US Army Corps of Engineers

Donlin Gold Project EIS

Comment Form

Figure 2: Snapshot of a portion of DEIS Figure 3.6-9 showing the model of pit lake inflow and outflow.

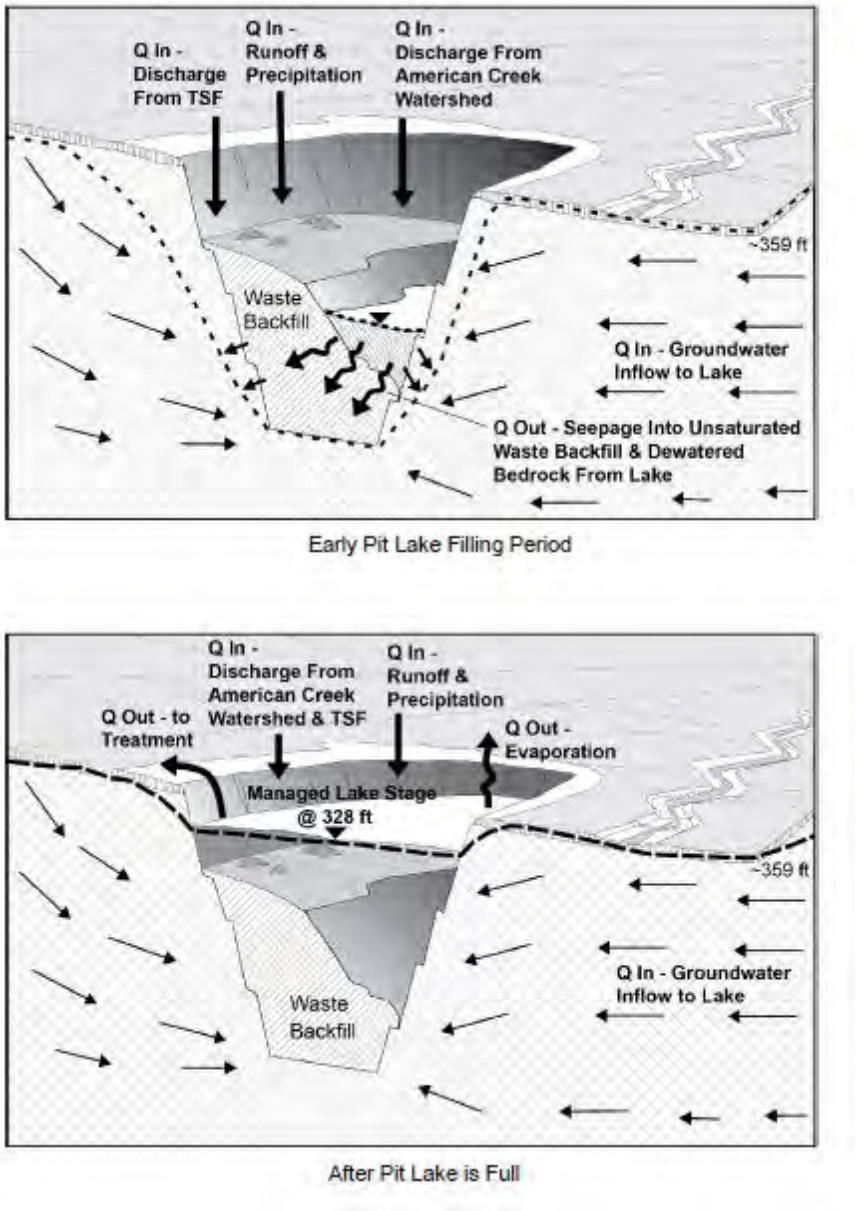
The DEIS discloses that pit lake water would discharge to surrounding groundwater both initially and in the long term (DEIS, p 3.6-35), as described in Figure 2. This is partly due to the placement of unsaturated backfill in the pit and to the fact that as the pit lake fills water from the pit lake will resaturate the surrounding bedrock. This differs from many pit lake systems which fill primarily by groundwater inflow, but at Donlin the bedrock K is low and does not recover immediately. Figure 3 shows simulated groundwater inflow and outflow at Donlin.

Partially backfilling the pit causes an interesting system of groundwater inflow/outflow at the pit lake. The backfill would be unsaturated at the beginning of pit lake formation and therefore has to be wetted as part of the pit lake formation by groundwater outflow from the pit lake to the backfill (DEIS, p 3.6-35) (Figure 2). BGC (2014c) describes the groundwater/pit lake relationship:

Figure 3: Snapshot of a portion of DEIS Figure 3.6-10 showing simulated groundwater inflow to and outflow from the pit lake as the pit fills with water.

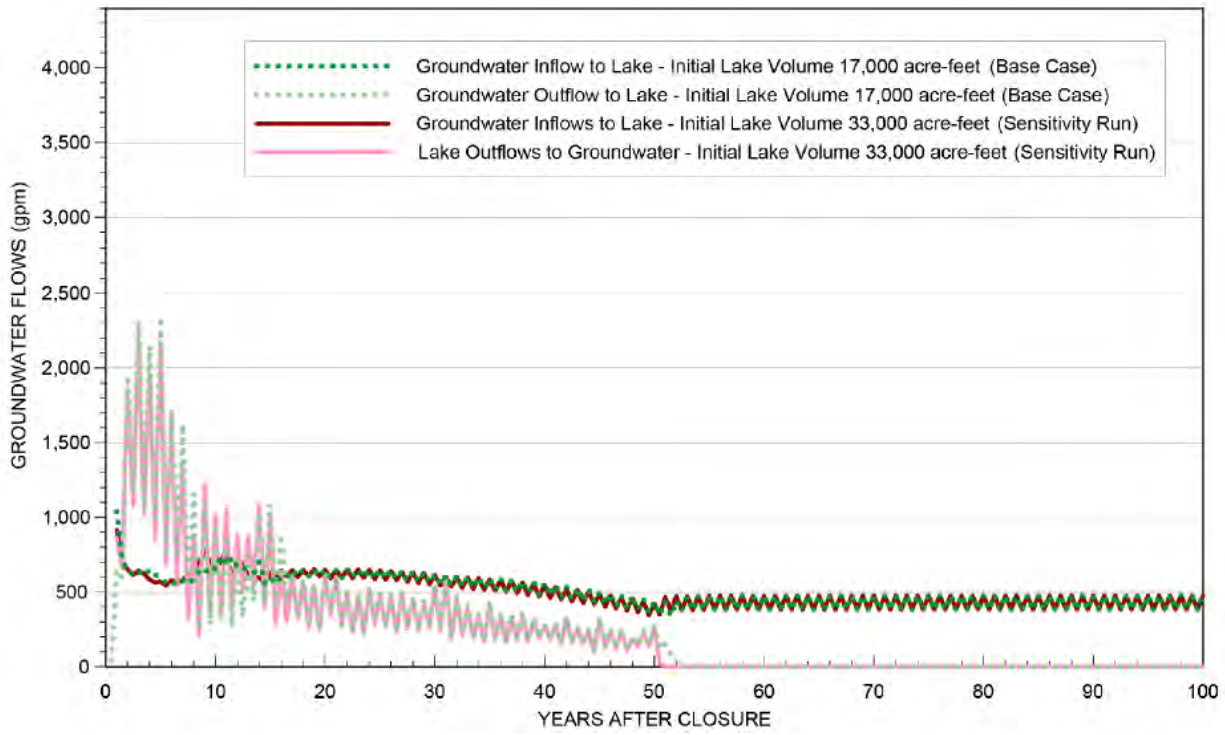
It is difficult to visualize how so much water leaves the pit lake and enters the surrounding groundwater (Figure 3), considering how the water table is hundreds of feet higher than the pit lake level (Figure 4). However, the modeling shows a significant outflow that is controlled partly by seasonal pit lake level changes. The net groundwater flow to the pit lake is very small (Figure 3) and the fact that discharge from the pit lake continues until the pit lake is almost full suggests pathways exist for flow to leave the pit lake and not return. This could occur at various depths depending on the details of the potentiometric surface.

Figure 4: Snapshot of Drawing 39 (BGC 2014c) showing simulated groundwater contours at the end of mining.

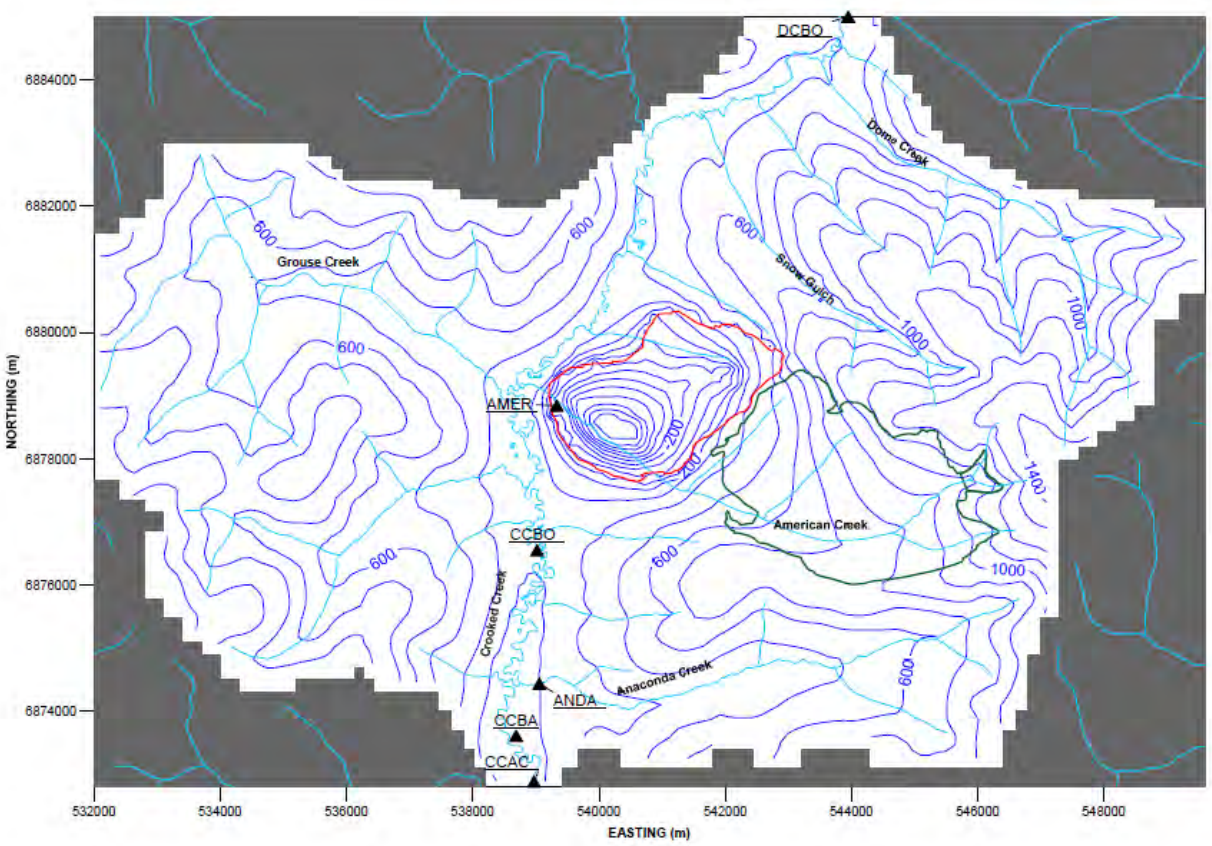
The groundwater contours at the end of mining suggest one possible pathway for contaminants to leave the pit and possibly enter surface water (Figure 4). Southwest of the pit the groundwater contours are much lower than northeast of the pit due to the general slope of groundwater in the area. If the pit lake fills faster than the surrounding groundwater table, as indicated by Figures 2 and 3, it is possible that the pit lake creates pressure in deeper bedrock that causes an upward gradient to the creek away from the pit. Pit lake water could flow through deeper bedrock layers then upward toward the surface due to higher pressure conditions in deep bedrock.

Figure 5: Snapshot of Drawing 45 (BGC 2014c) showing reductions in flow from various Crooked Creek tributaries due to mine dewatering.

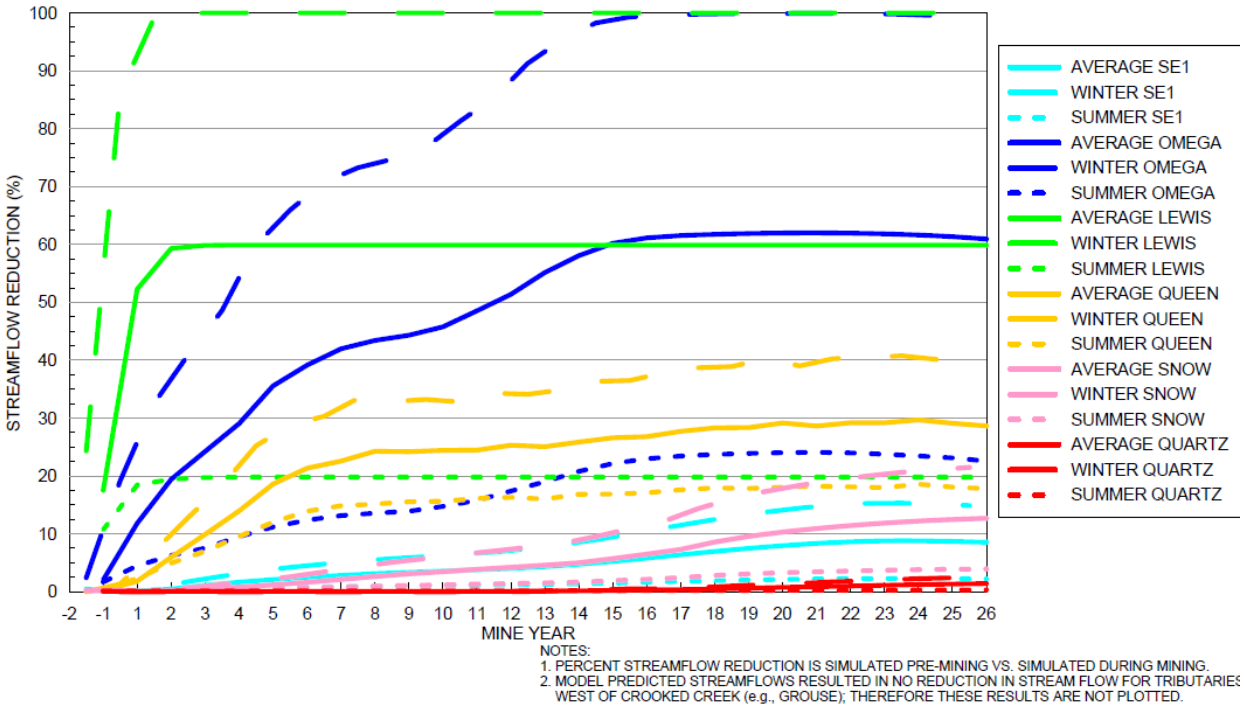
Pit construction affects streamflow in two ways. First, dewatering to keep the pit dry would intercept groundwater flowing toward a stream where it would be become baseflow. Dewatering will reduce streamflows by up to 10 and 30 % during summer and winter, respectively (BGC 2014c, Drawing 44). Figure 5 shows reductions in groundwater discharges to various Crooked Creek tributaries caused by dewatering (BGC 2014c, p 40). The impact of dewatering decreases with distance from the stream.

Figure 6: Snapshot of a portion of Drawing 39 (BGC 2014c) showing the bedrock potentiometric surface at the end of mine operations.

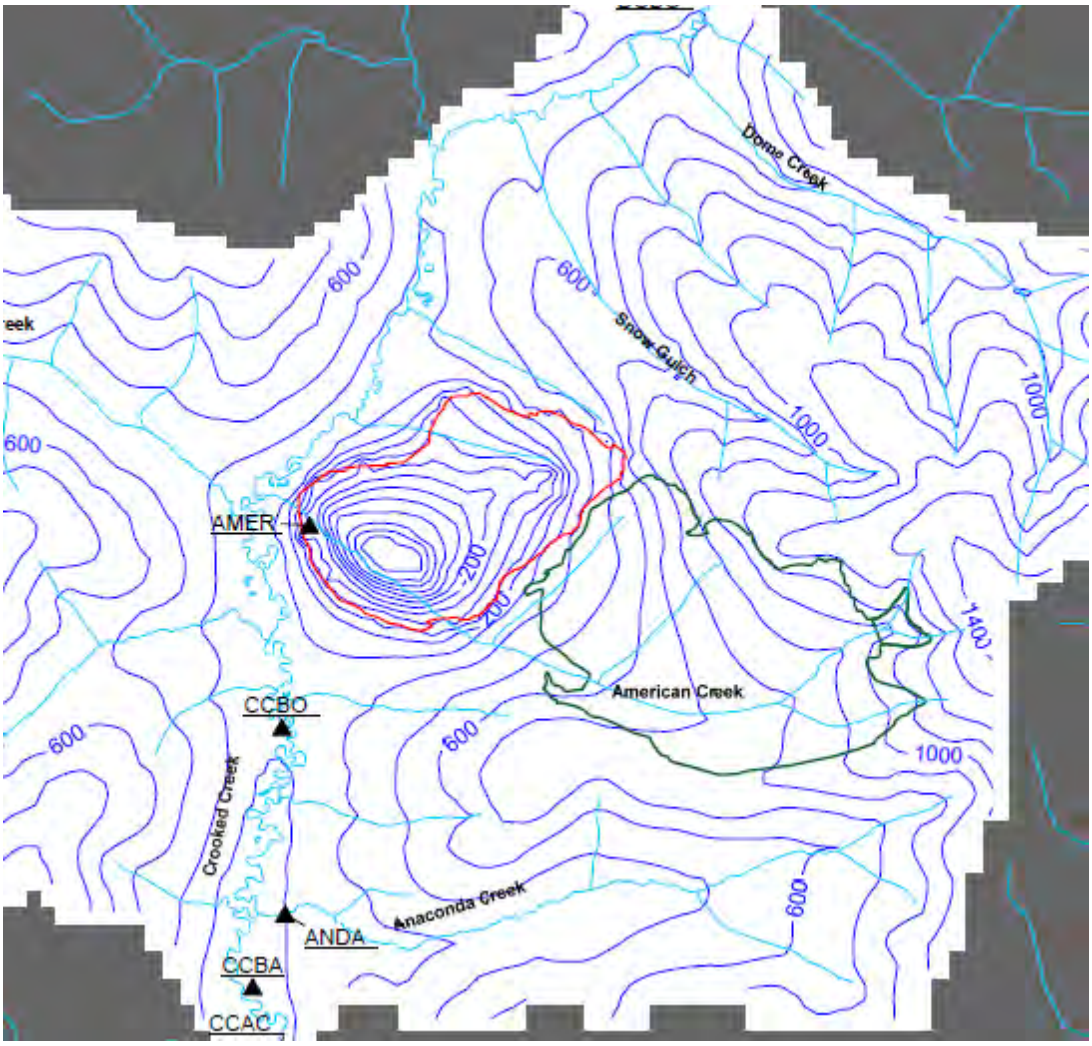
PAA 9 The tailings facility is not within the pit capture zone, as shown in Figure 6. The tailings facility would lie over the Anaconda Creek drainage at the bottom of the figure. Although most of the watershed has drawdown due to the tailings impoundment capturing recharge (BGC 2014c, Drawing 40), the groundwater contours show that most of the Anaconda Creek watershed would drain to the low point beneath Anaconda Creek. The creek would lose substantial water due to a loss of recharge due to the tailings. Seepage however would report to the colluvium beneath Anaconda Creek and then to Crooked Creek.

Figure 7: Snapshot of a portion of BGC (2014c) Drawing 17 showing parameter zones in model layer 1. See Figure 9 for a legend.

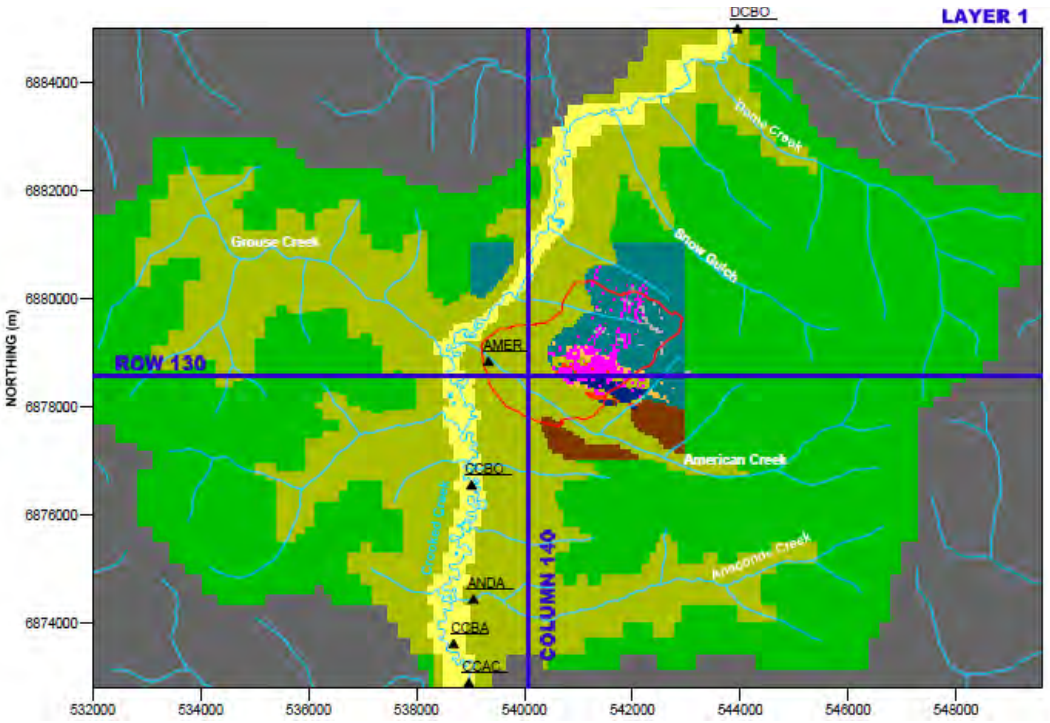
Model layer 1 has a sharp transition from alluvium along Crooked Creek to colluvium surrounding the alluvium (Figure 7). Conductivity changes from 300 to 0.6 ft/d along a long reach of the stream. Such large changes in K between adjacent cells often leads to water balance errors in the model solutions. BGC should address the potential for local errors which
GRD 1 can lead to large inappropriate head changes. Conductivity of the valley Kuskokwim formation, which underlies the alluvium (Figure 8), ranges from 0.1 to 0.3 ft/d (BGC 2014c, Table 7). Effectively, the model simulates the high K alluvium as being surrounded by very low K bedrock or colluvium which essentially disconnects the alluvium from the rest of model domain; the model conceptualization as simulated here effectively isolates the alluvium. Using more appropriate K values to simulate the alluvium and surrounding formation would provide a more accurate simulation of flow across the formation boundaries and of the surface/groundwater interchange at Crooked Creek.

- The model simulates the alluvium with a very high K surrounded by low K bedrock and colluvium. This effectively isolates the alluvium and minimizes the effects of dewatering on the stream.

Figure 11: Snapshot of a portion of BGC (2014c) Drawing 37 showing drawdown in model layer 1, the surficial aquifer.

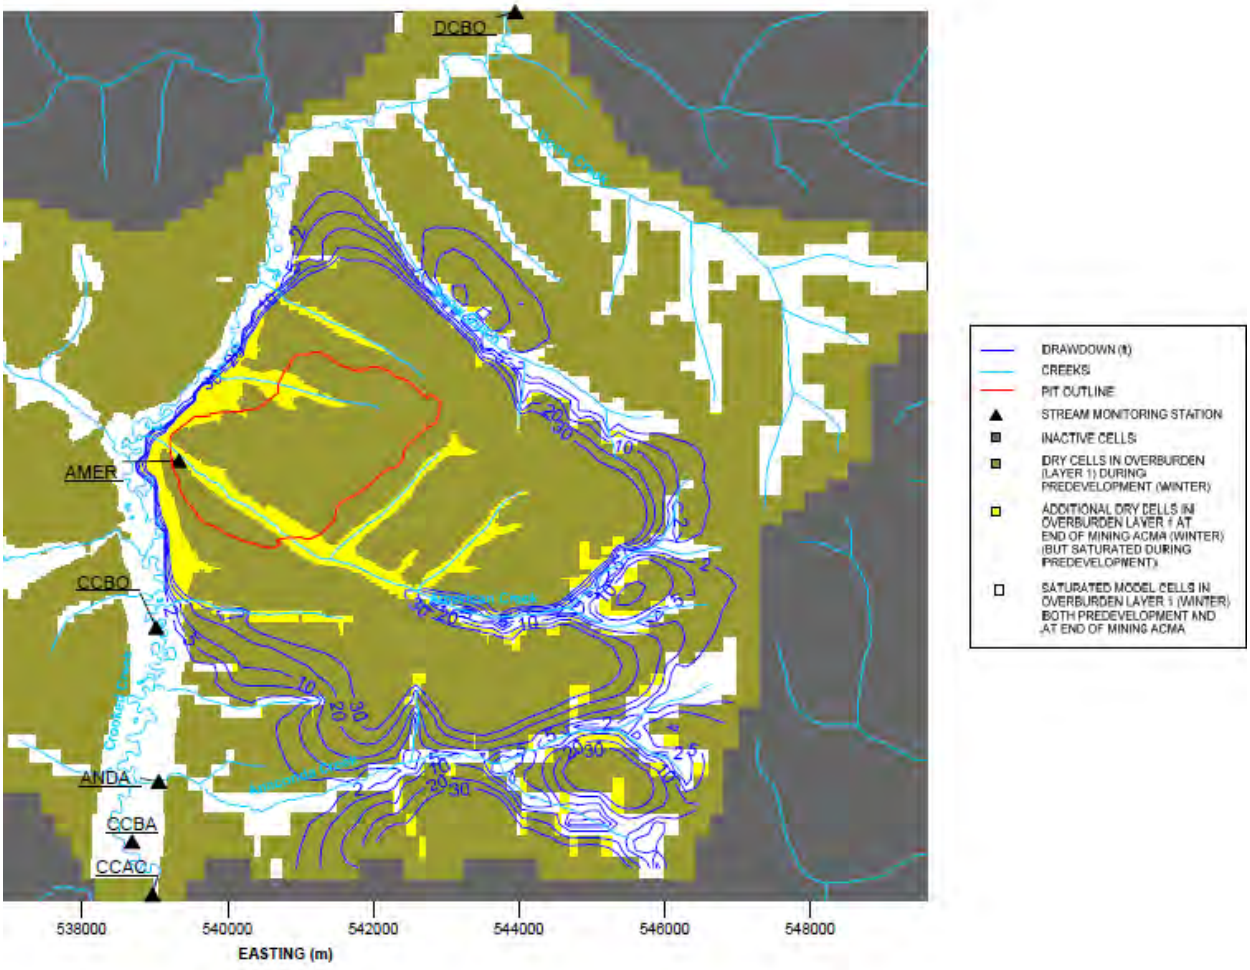
Dewatering dries much of layer 1 as can be seen by the 30 foot drawdown contour encircling much of the area (Figure 11). The model cells within that area would be dry. As noted in the
GRD 1 text (BGC 2014c, p 39), drawdown in the alluvium along Crooked Creek is less than two feet. The lack of drawdown corresponds to the high K and encirclement by low K bedrock and colluvium as described above. The alluvium is effectively isolated from the effects of dewatering (Figure 11) by the model design.

Figure 12: Snapshot of BGC (2014c) Drawing G22 showing the discharge to the tailings impoundment underdrain for the base case and various sensitivity analysis simulations.

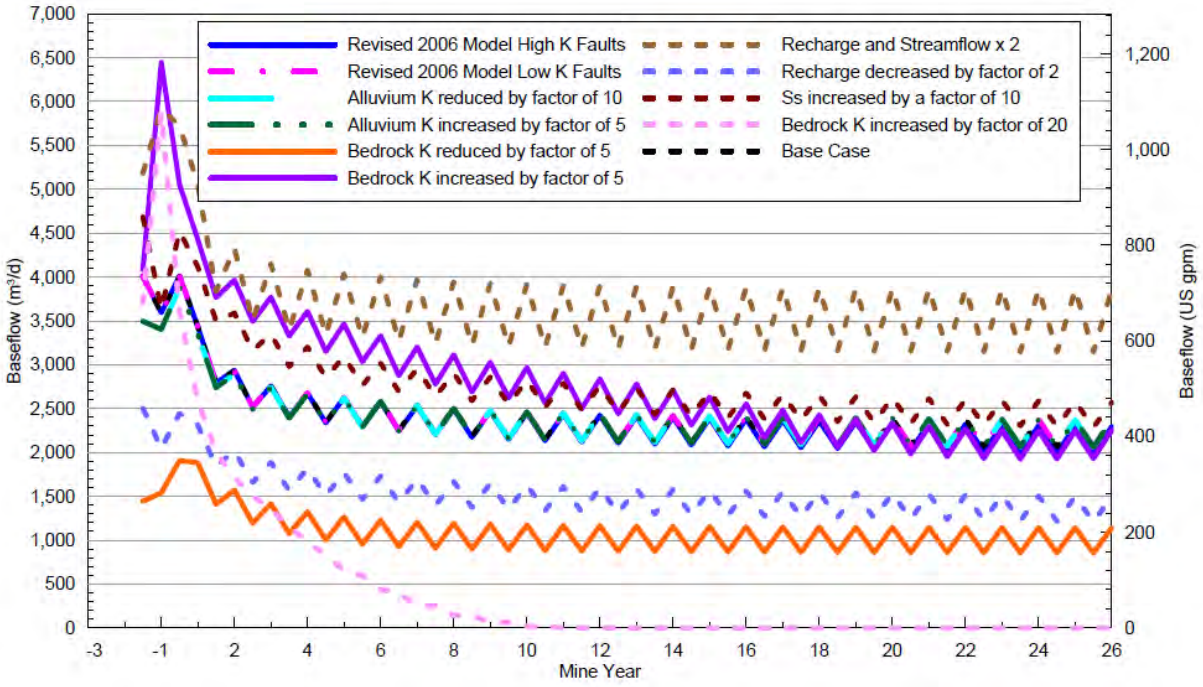
The groundwater model (BGC 2014c) estimated discharge to the tailings impoundment underdrain (Figure 12). The only description of how the TSF was simulated was to note that ET and recharge was set equal to zero (BGC 2014c, p 16, 34).

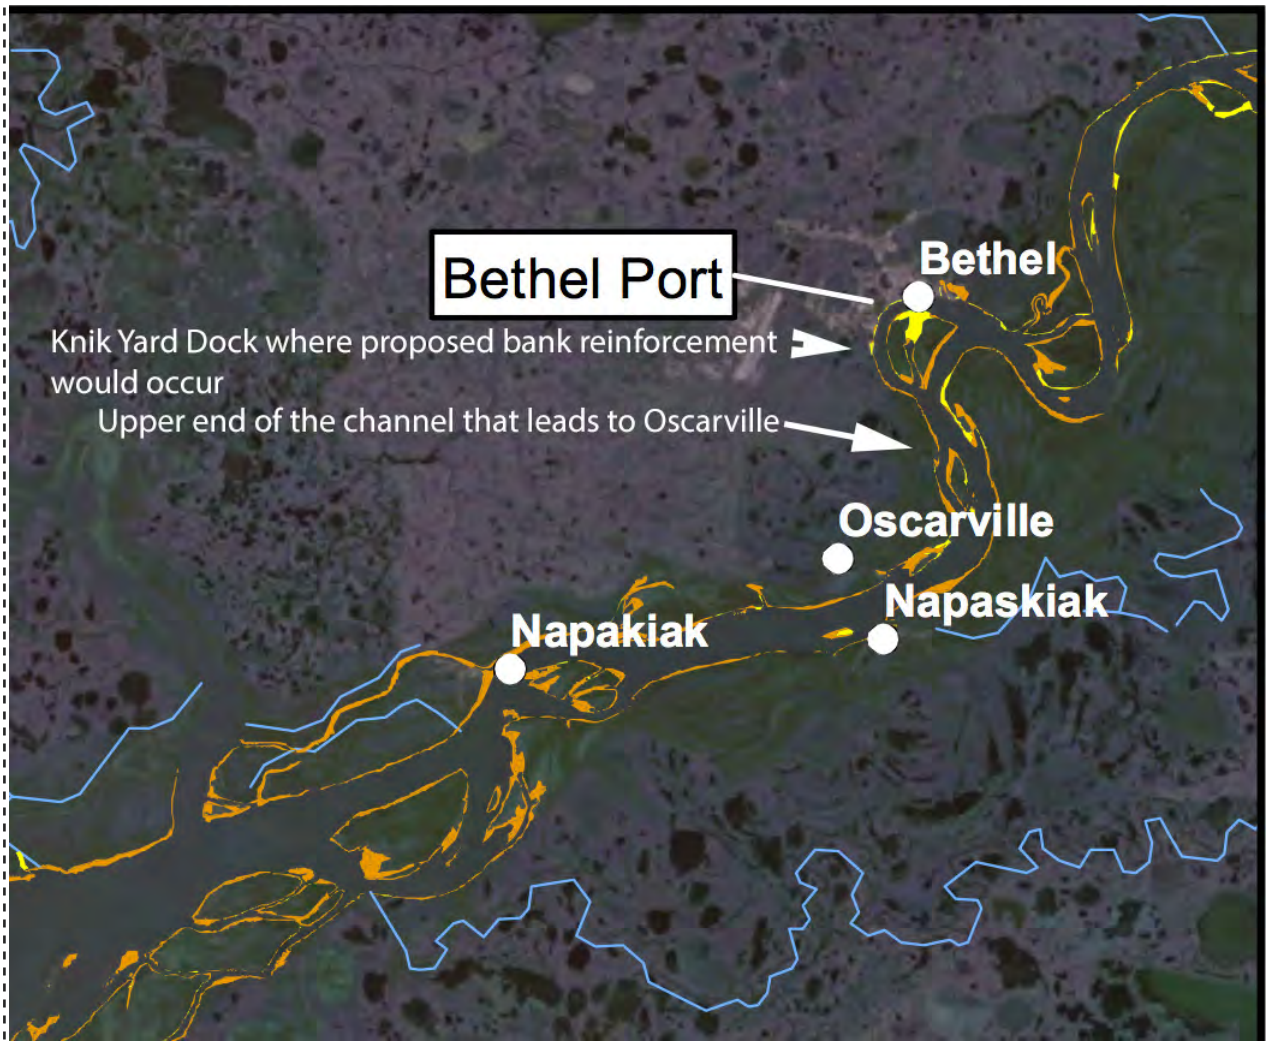
The figure below is taken from Figure 3.5-13 of the DEIS and denotes the depositional areas in yellow and the actively eroding sections of channel in orange. Note how the upper end of the side channel that flows past Oscarville (and is less than one mile below the proposed port site) is labeled as susceptible to erosion as well as much of the west bank of the Kuskokwim River between Bethel and Oscarville.

BARG 11 **A thorough analysis by a hydrologist who specializes in large river systems should have been included in the Draft EIS, and must be considered in the Final EIS so that residents of the region are fully aware of potential trade-offs.**
